SS 705-WST 2021 49X XMC Output Reliability

49X vehicles built with XMC

Reliability issue with the six 20 Amp outputs (D01-D06) on the XMC's

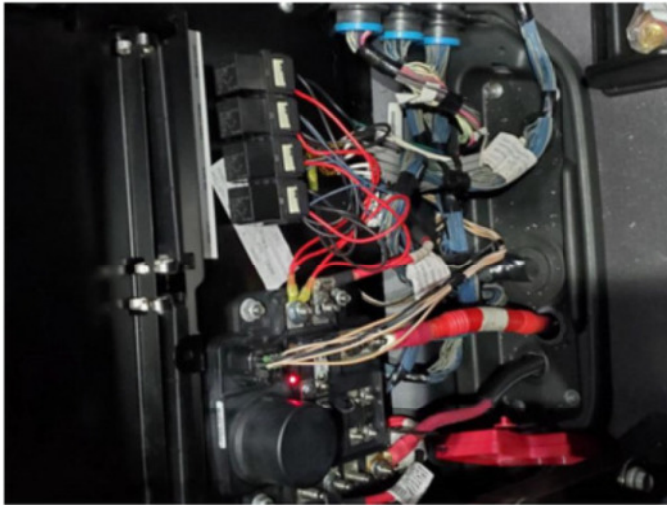
For Western Star 49X trucks that implement XMC's, there is more than one way to take advantage of the flexible programming capabilities, using the CHEC tool to program existing XMC's in the field. For reference, to output names and wiring on Western Star 49X wiring, refer to PartsPro subgroup 35M per serial number.

On the XMC's, there are four 5 Amp outputs (D07-D10), and eight 2 Amp outputs (D11-D17). All of the 5 and 2 Amp outputs are working reliably on XMC's. If your current requirements do not exceed these ratings, you can freely program the XMC's for your purposes and connect to the output pins.

example of field modification (dealer supplied materials, see per serial module 35M for correct part numbers):

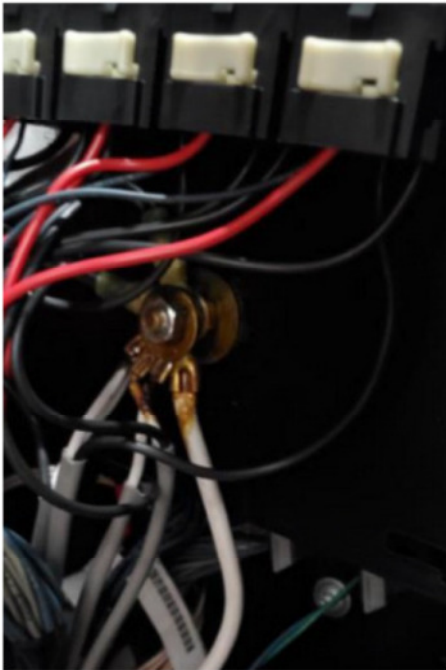
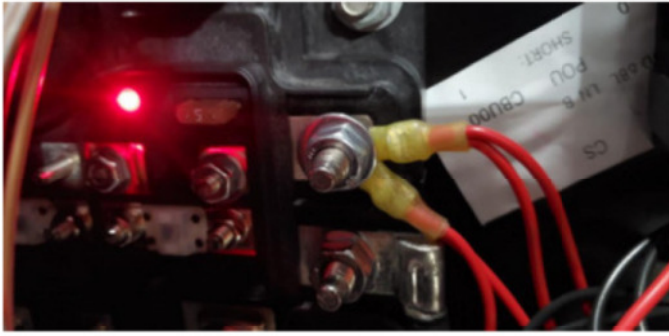
Applications that require higher current capacity may use any of the 2 or 5 Amp outputs to trigger relays to source higher current. There is the option of adding relays individually on a 49X or you can choose the process noted in the paragraph below. Referring to schematic G66-17097-002 (see attached document) in PartsPro module 35M for sample truck S/N MS2152 will provide useful diagrams to implement relays.

There is a released sales code as a viable factory option for higher current applications. It uses 2 Amp outputs to control relays. Sales code 35M-012 (refer to truck S/N MS2152 for wiring information) provides eight 20 Amp, relay driven circuits. Modifying trucks to this sales code provides a feature documented and supported by DTNA. To implement a new sales code on an existing Western Star, follow Service Bulletin 00-004 to submit the truck and desired features to the Modifications department.

Do not use sales code 35M-011 as a solution, the 20A relay circuits in that configuration use the same 20A outputs that are currently failing as the trigger for the relays.
